US 1/SR 4 Bridge Replacement Over Altamaha River, Overflow 1 and Williams Creek

BR000-0001-00(216), P.I. No. 0001216
Appling and Toombs Counties, Georgia

Value Engineering Study Report

February 2010

Use Temporary Easement instead of Right-of-Way from
STA 47+50
 to
STA 86+00

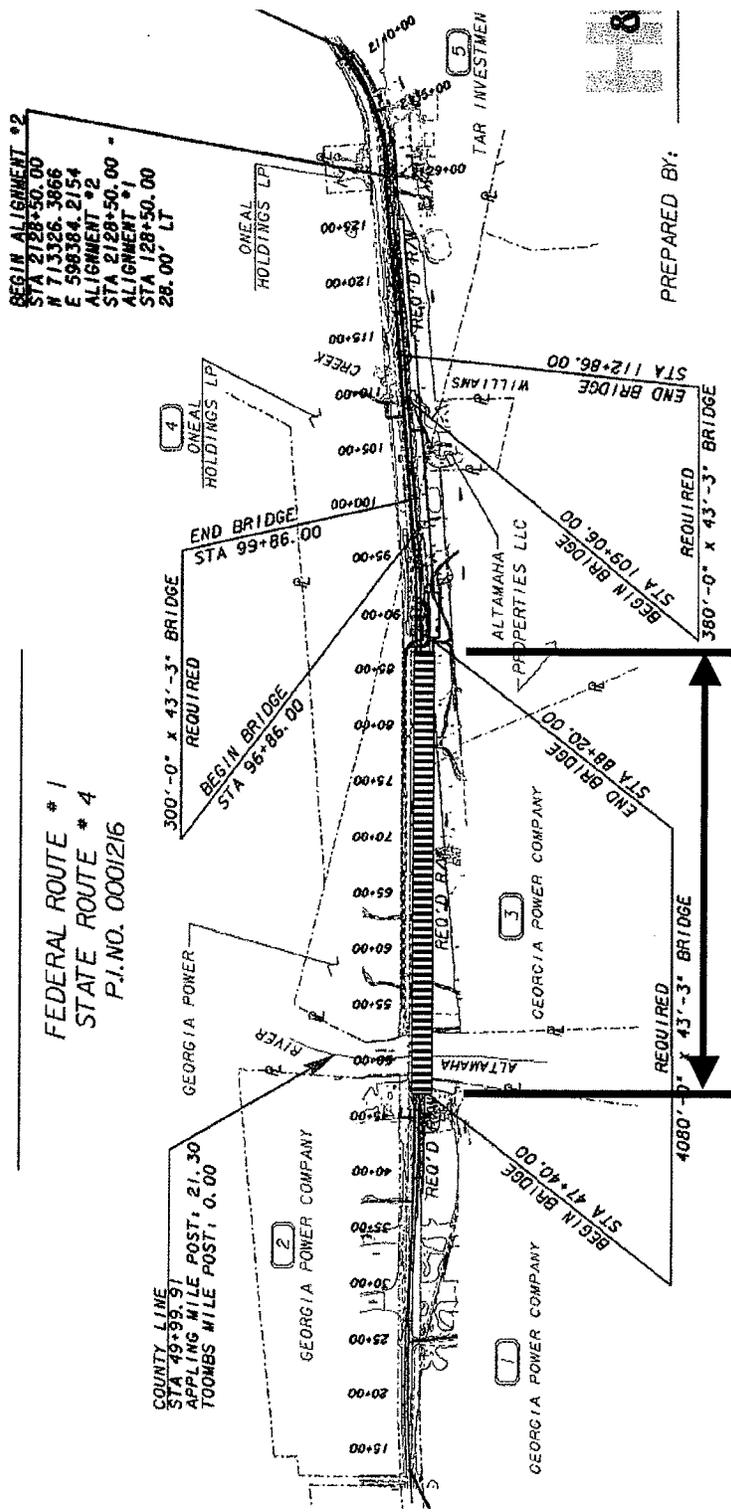
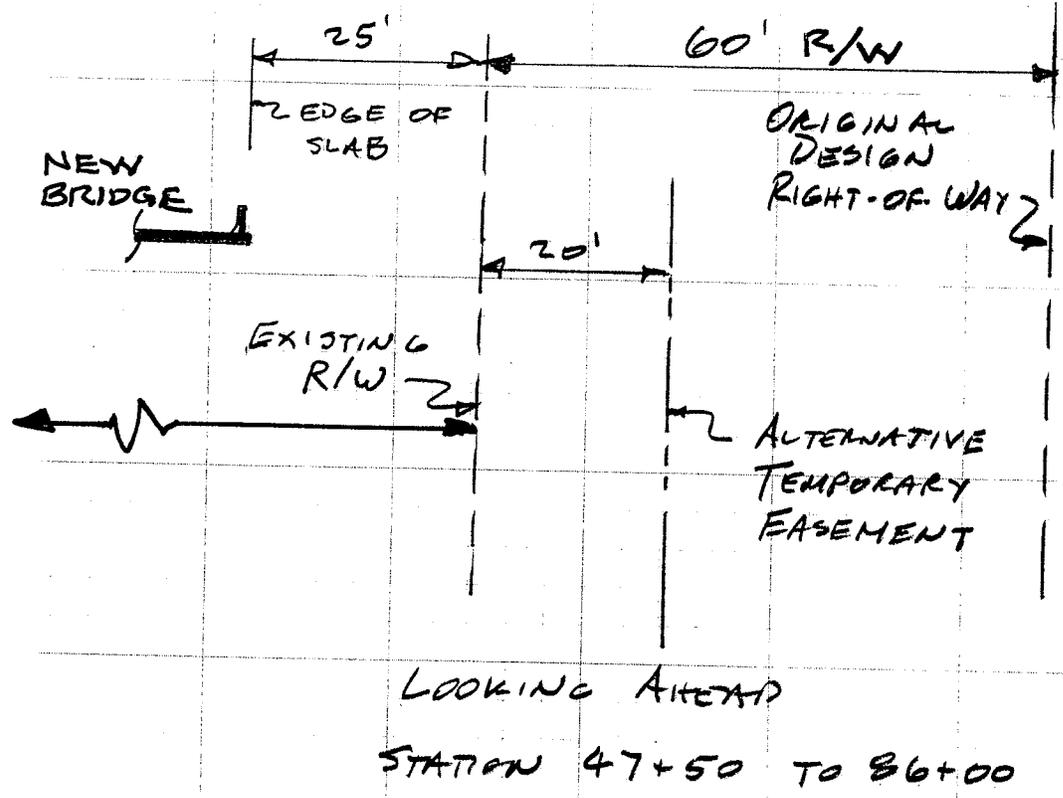
- Modified right-of-way approach

The edge of the new bridge is about 25 ft. inside the existing right-of-way which provides adequate access for future maintenance of the bridge. Purchasing a 20 ft. strip of temporary construction easement will provide adequate room for the contractor's use in constructing the bridge and reduce the right-of-way required.

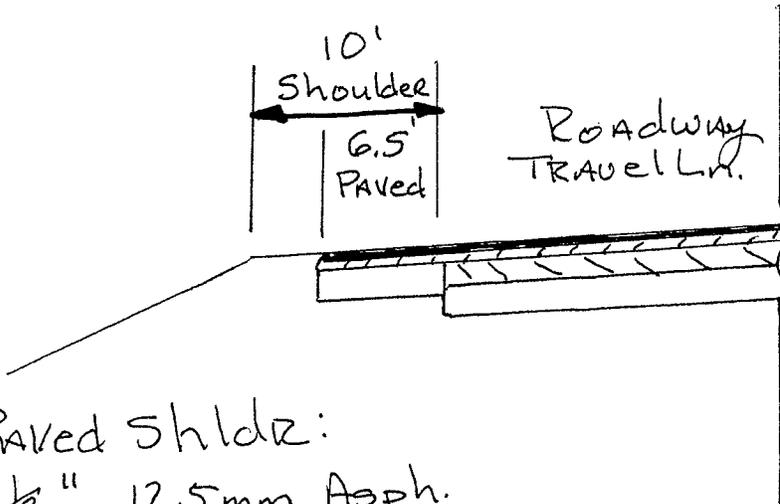
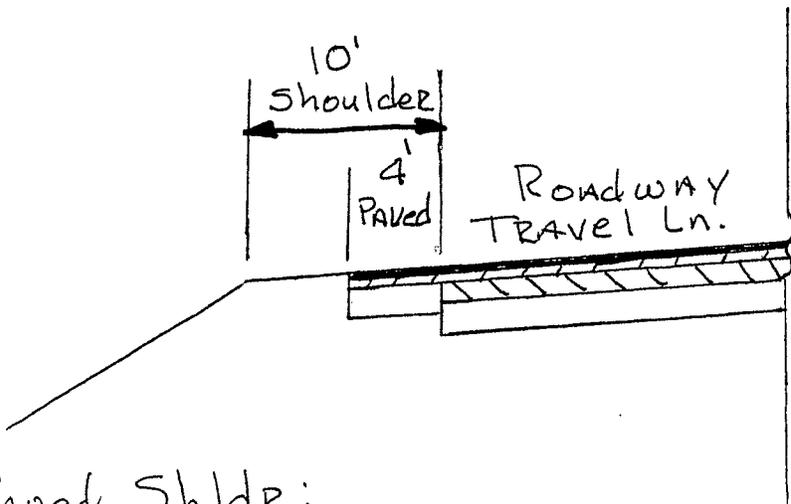
Originally, the 6.5 ft. paved section was used on designated bike routes in the state, but this section of US 1/ SR 4 is not a designated bike route. It is important to note that even though this route will eventually be widened to four lanes, it is still acceptable design practice to use a 4-ft.-wide paved section on the shoulders.

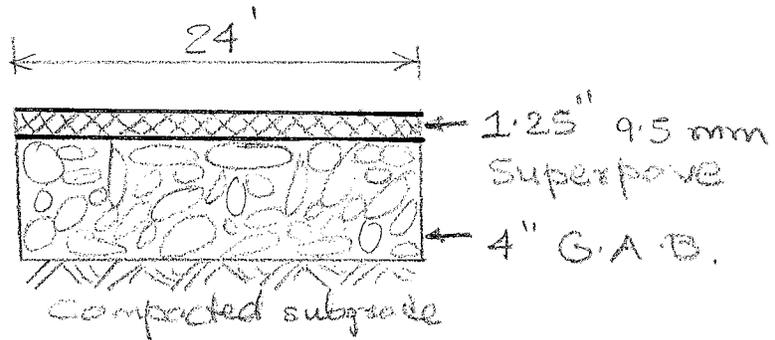
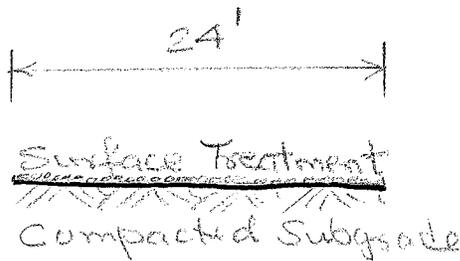
The current access road to the boat ramp is a dirt road. This access road appears to be frequented by fisherman only. By only surface treating the road instead of constructing a full depth pavement, a considerable amount of material and labor can be saved. The resulting road connecting US1/SR4 to the dirt road will be a stable section with good drainage capability although it will require more maintenance than an asphalt section would.

ALTERNATIVE NO.: S-5

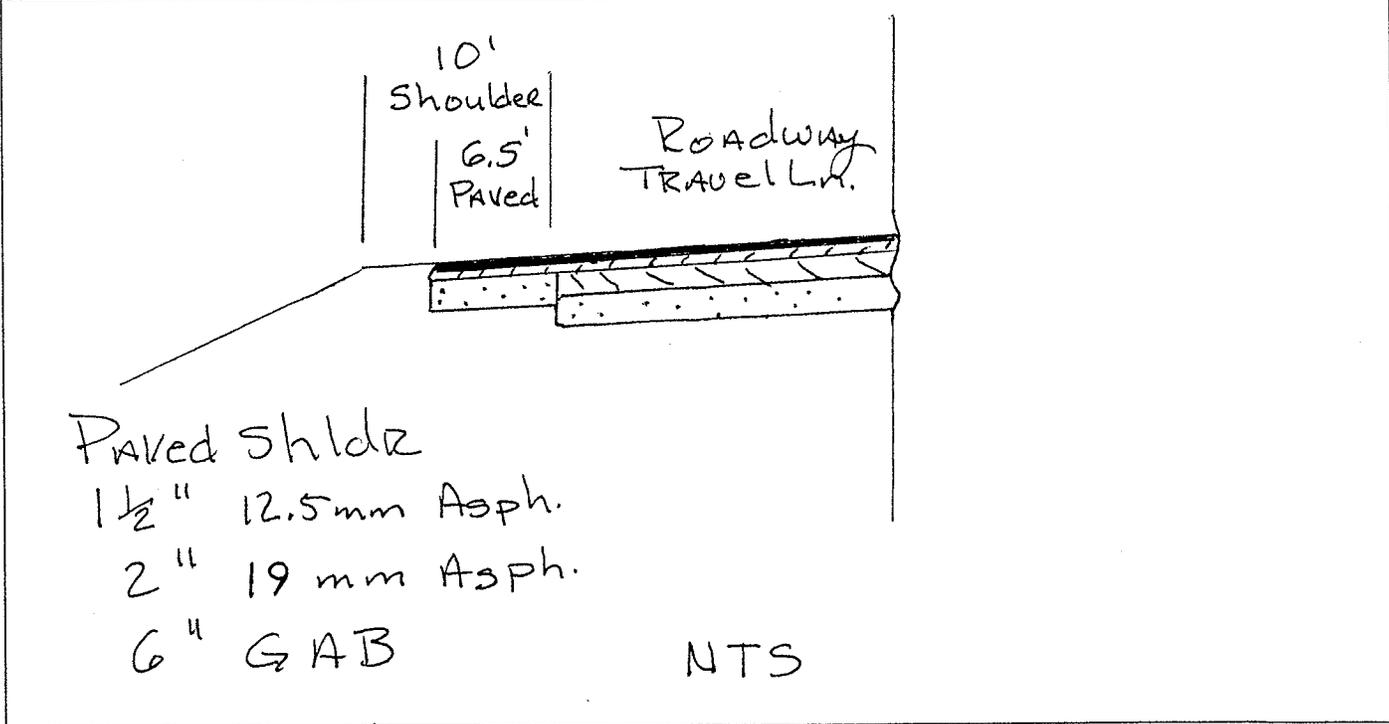
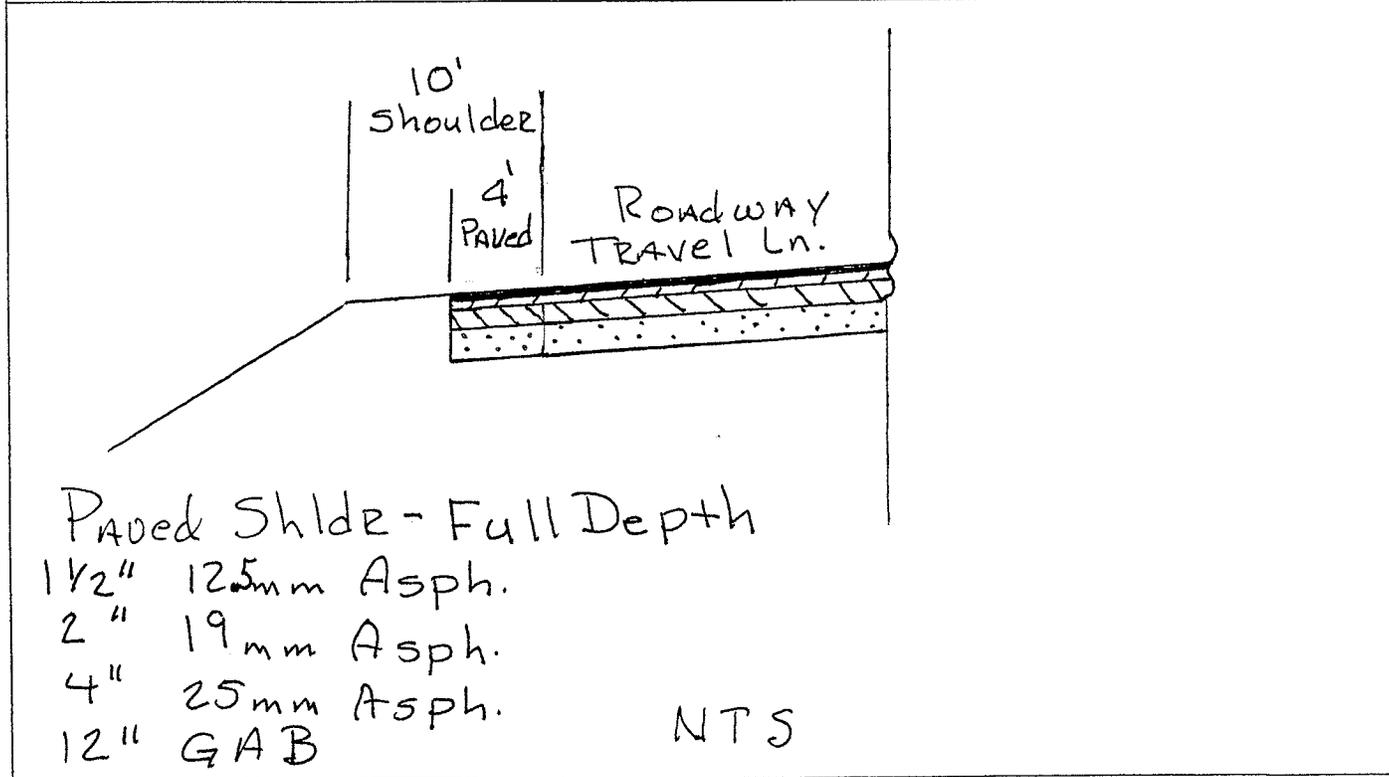
The original design uses a thin paved shoulder that may not be as durable near the heavy truck traffic (18.5 %). The alternative design uses a full-depth pavement shoulder that would be the same pavement structure as the travel lanes. This thicker paved shoulder section will improve bearing capacity and will have a significantly longer life than the thinner pavement section. Reducing the paved section width from 6.5 ft. wide to 4 ft. wide is acceptable design practice for this type of highway and aids in offsetting the added material and labor requirements for the full depth pavement. The added durability and reduction in future maintenance requirements results in a net savings when viewed from a 30yr life cycle perspective.

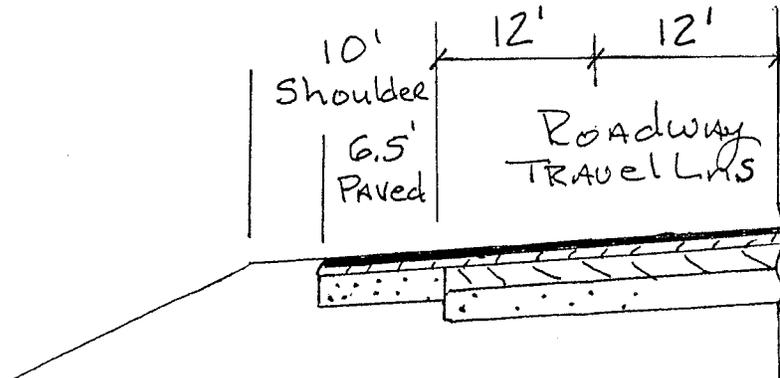
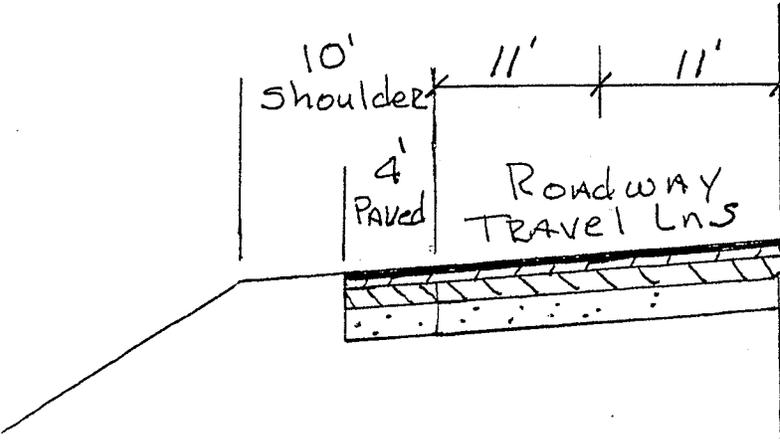
The main idea behind this alternate is to provide full-depth pavement on a narrower shoulder adjacent to the 11-ft.-wide travel lanes. The savings in the life cycle costs will make this alternate more cost effective than the Original Design. Also, since this road is a designated Governor’s Road Improvement Program (GRIP) corridor, the roadway will eventually be widened to four lanes and the two lanes under consideration will become one-way. In light of the future four lane concept, the 11-ft.-wide travel lanes are a logical choice.

**BRIDGE #1
PARTIAL PLAN & ELEVATION**

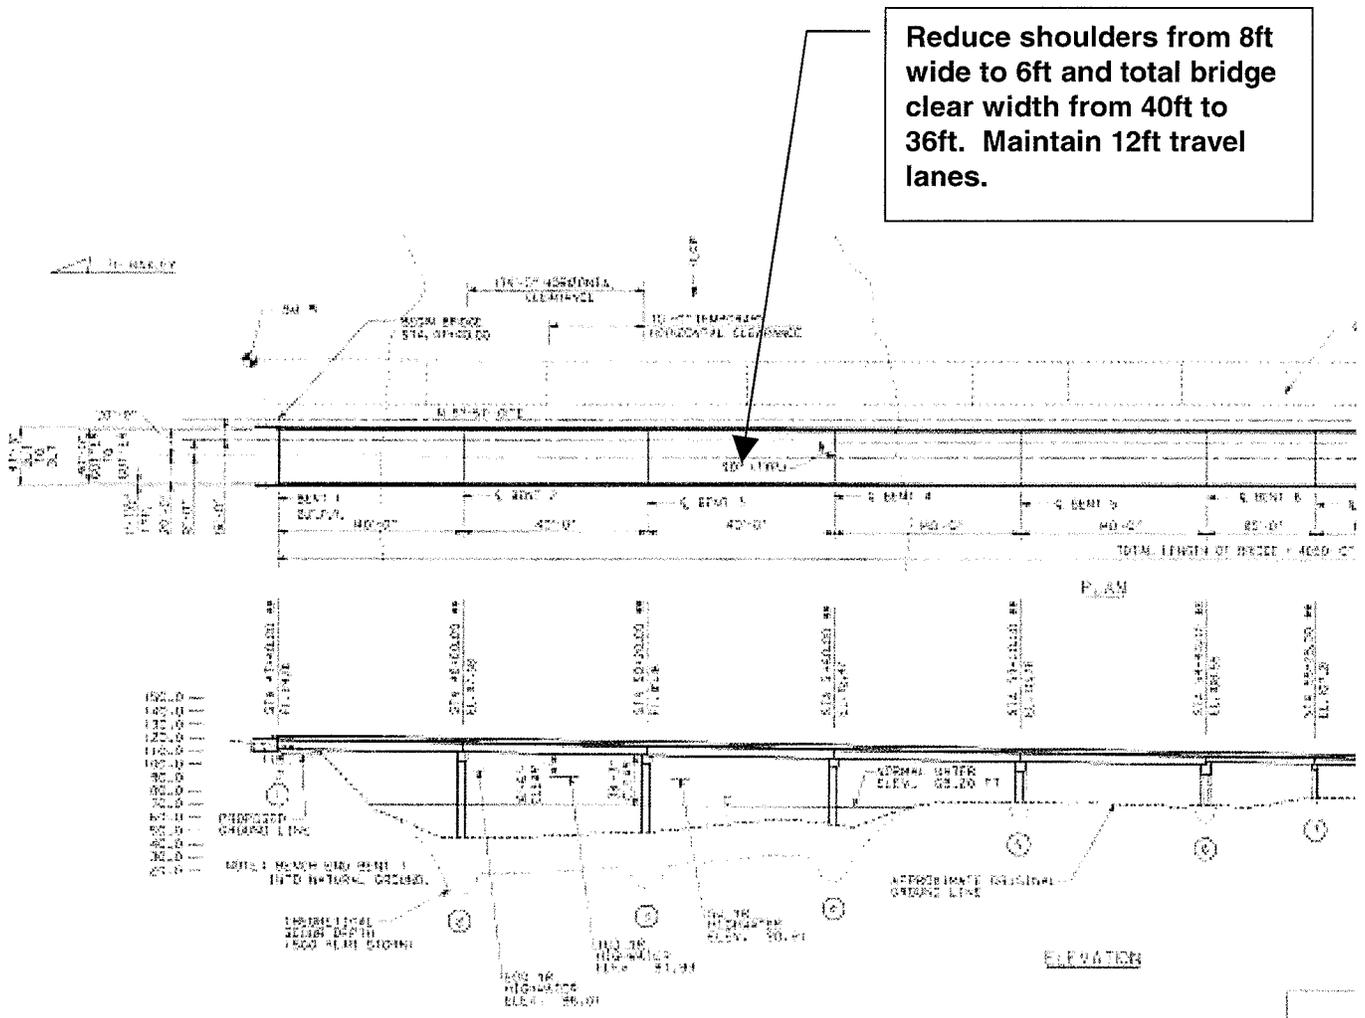
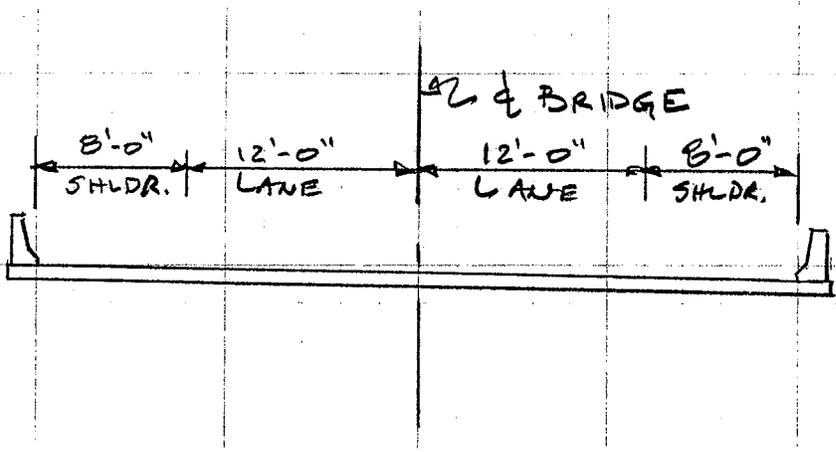
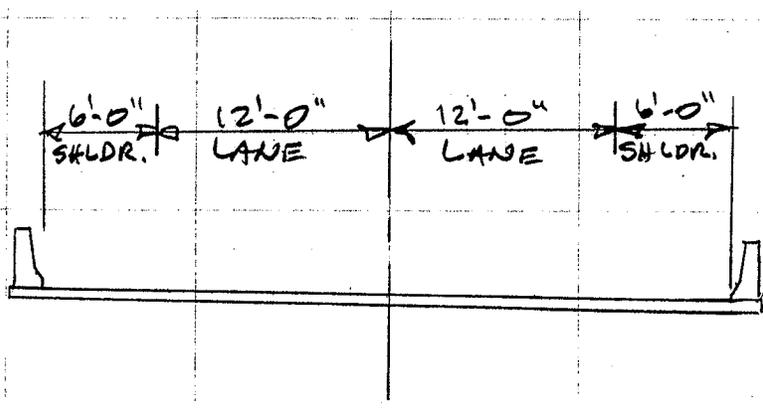
The GDOT Bridge and Structures Design Policy Manual calls for gutter-to-gutter widths of 40 ft. for two-lane state routes with ADT over 2,000, and 36 ft. for multi-lane divided state routes with ADT over 2,000. While this route will have only two lanes in the initial construction phase, the future project will widen the road to a four-lane section to meet the requirements of a GRIP corridor. Since the bridges make up nearly half the length of this project, reducing the bridge width will greatly reduce the material and labor requirements for this phase of construction.

BRIDGE #2 (OVERFLOW #1)
PLAN & ELEVATION
 (Length = 300ft)

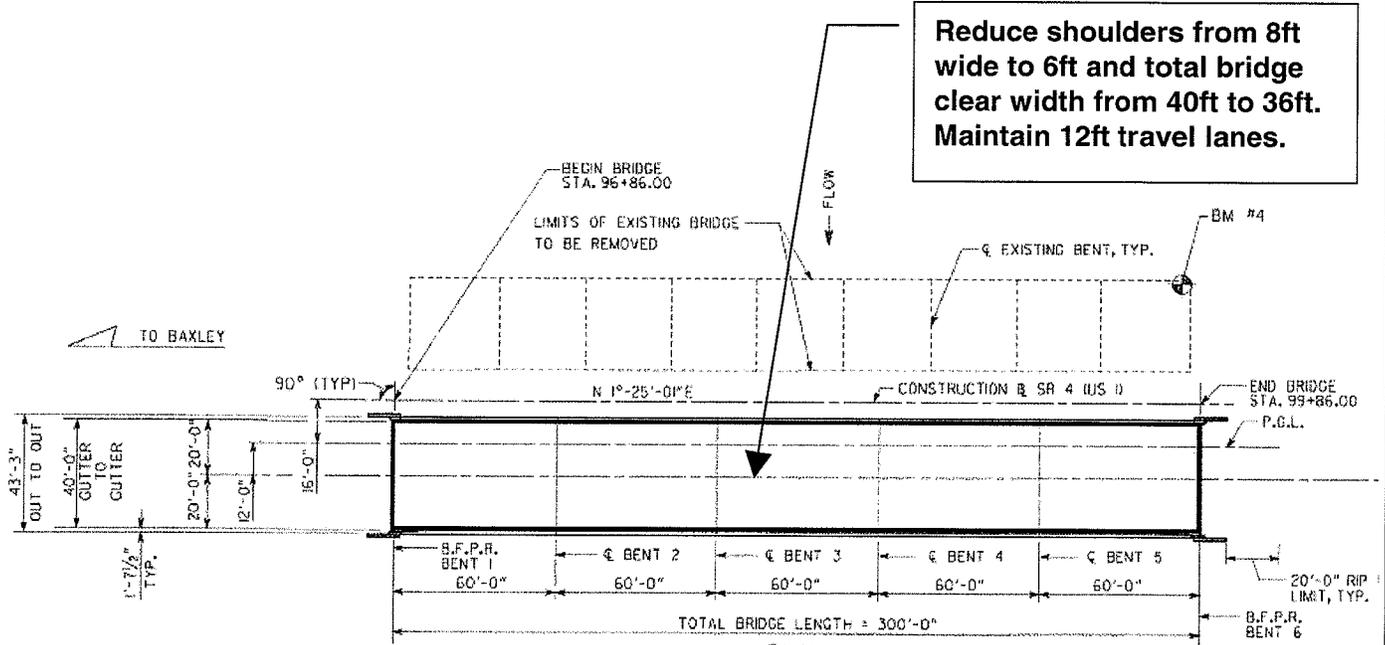
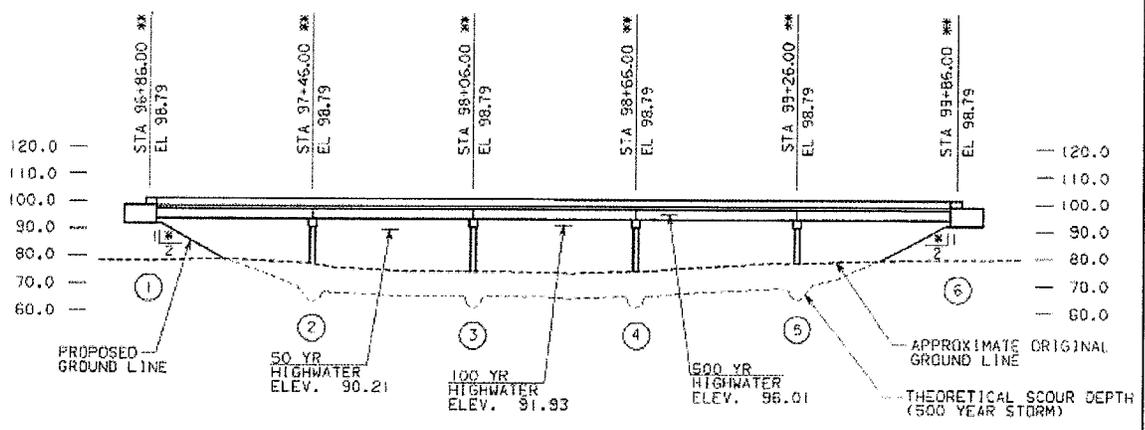
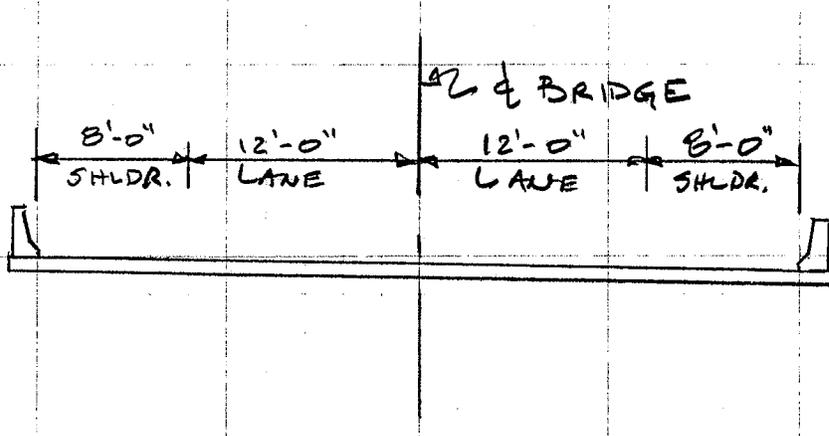
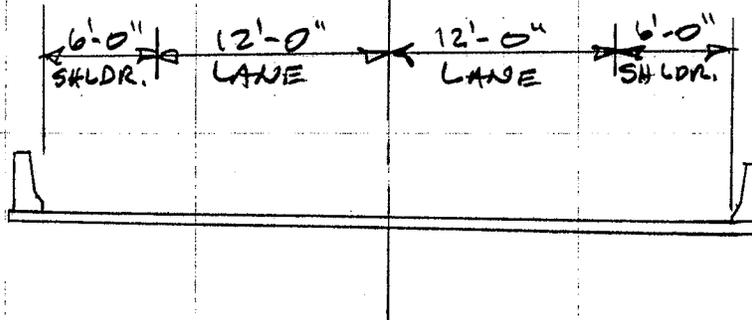
The GDOT Bridge and Structures Design Policy Manual calls for gutter-to-gutter widths of 40 ft. for two-lane state routes with ADT over 2,000, and 36 ft. for multilane divided state routes with ADT over 2,000. While this route will have only two lanes when this initial phase of construction is completed, a future project will widen it to a four-lane section meeting the GRIP corridor criteria. Since the bridges make up nearly half the length of this project, reducing the bridge width will greatly reduce construction material and labor requirements.
